Access Compliance Report Public Rights-of-Way (Curb Ramps)

Main Street: LUCERO_WAY Cross Street: HOLT_AVE Location: NW

ADA ID: RPRK220121122159 Ramp Type: Type 4 - Parallel Initial Pass/Fail: Fail Overall Compliance: No Severity Score: 2

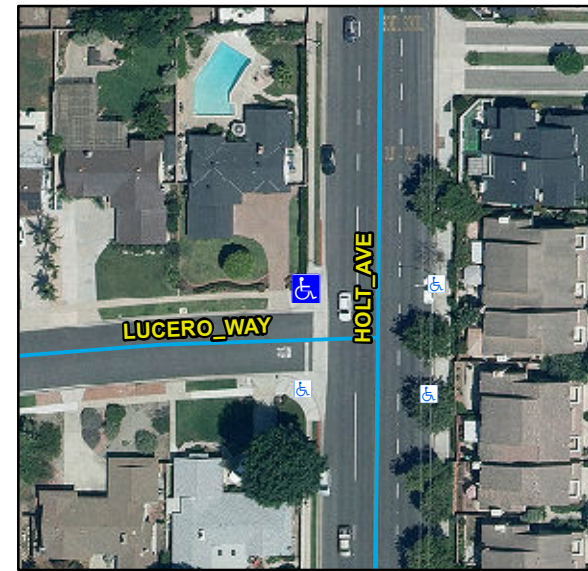
Compliance	Description	Data	Compliance	Description	Data
N/A	Ramp Length LT (in)	87	N/A	Ramp Length RT (in)	92
Yes	Ramp Width LT (in)	84	Yes	Ramp Width RT (in)	84
Yes	Ramp Run Slope LT (%)	7.1	Yes	Ramp Run Slope RT (%)	7.3
Yes	Ramp Cross Slope LT (%)	1.2	No	Ramp Cross Slope RT (%)	3.8
N/A	Landing Present	N/A	N/A	DWS Provided	N/A
N/A	Landing Length (in)	N/A	N/A	DWS Contrast	N/A
N/A	Landing Width (in)	N/A	N/A	DWS Length (in)	N/A
N/A	Landing Run Slope (%)	N/A	N/A	DWS Full Width	N/A
N/A	Landing Cross Slope (%)	N/A		DWS Offset Type	N/A
N/A	Landing Movement Obstructed?	N/A	N/A	DWS Offset Left (in)	N/A
	Landing Movement Type	N/A	N/A	DWS Offset Right (in)	N/A
N/A	Landing Shared	N/A			
N/A	Clear Space	Yes			
N/A	Clear Space To Crosswalk (in)	N/A			
N/A	Marked Crosswalk 1	No	N/A	Marked Crosswalk 2	No
	Crossing 1 Direction	S		Crossing 2 Direction	E
	Marked Crosswalk 1 Width (in)	N/A		Marked Crosswalk 2 Width (in)	N/A

Remove & Replace Curb Ramp With Two New Directional Ramps or Equivalent.
